Tel: +1 416 754-3322 Fax: +1 416-754-3299 Email: support@edac.net http://www.edac.net ENGINEERING CHANGE NOTICE					
Originator:	: Mit Patel		Date:		Document Number		
Phone No.	4	16-754-3322					
Email Address:	mpa	atel@edac.net		March 24, 2025	202	250324-00	
Department		Quality		Revision Number	er SHEET		
CHANGE TYPE:				1		1 of 3	
CLASS I	CLASS I Customer notification and approval required prior to implementation Customer notification only, no approval required CLASS III No customer notification required						
Specification Update							
DESCRIPTION OF CHA	NGE:						
15u" gold plating option h 001 on page 2.	nas been added to the r	new revision. Th	ne part number f	or that is 628-392-001.	Please see the updat	ed drawing 628-292-	
A	628-592-001 628-392-001	628-292-001 GOLD FLASH PLATING ON MATING AREA, 50μ" NICKEL IN CRIMP AREA 628-592-001 10μ" GOLD PLATING ON MATING AREA, 50μ" NICKEL IN CRIMP AREA 628-392-001 15μ" GOLD PLATING ON MATING AREA, 50μ" NICKEL IN CRIMP AREA

13A-F002 Engineering Change Request (Supplier) Revision Level: N

210711011. 020 200 7011, 020 200 70110										
	DRAWN BY		J.S.M.	628 SERIES TERMINAL						
DRAWN DAT			03/13/2025	CRIMP AND LOAD SOCKET						
CHEC

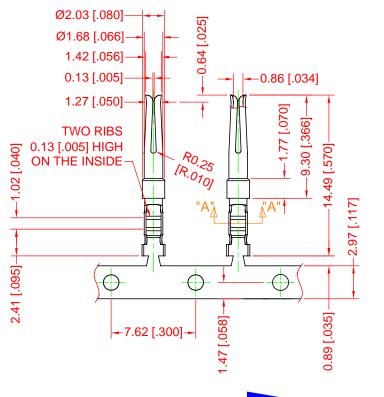
REVISIONS						
REV.	DESCRIPTION	DATE	BY			
1	ORIGINAL	06/10/2015	R.S.M.			
2	NICKEL PLATING WAS TIN PLATING	06/24/2015	R.S.M.			
3	BRASS WAS PHOSPHOR BRONZE	09/03/2015	R.S.M.			
4	ADD WIRE GAUGE RANGE IN NOTES	11/23/2018	Y.ZHANG			
5	28~24 AWG WAS 28~22 AWG	12/09/2020	P.M.			
6	ADD NOTE 5	11/16/2022	J.L.			
7	UPDATE NOTE	03/01/2023	J.L.			
8	ADD 628-392-001, UPDATE TEMPLATE, ADD TOLERANCE, UPDATE PLATING	03/13/2025	J.S.M.

8 628-392-001 628-692-001 15μ" GOLD PLATING ON MATING AREA, 50μ" NICKEL IN CRIMP AREA 30μ" GOLD PLATING ON MATING AREA, 50μ" NICKEL IN CRIMP AREA
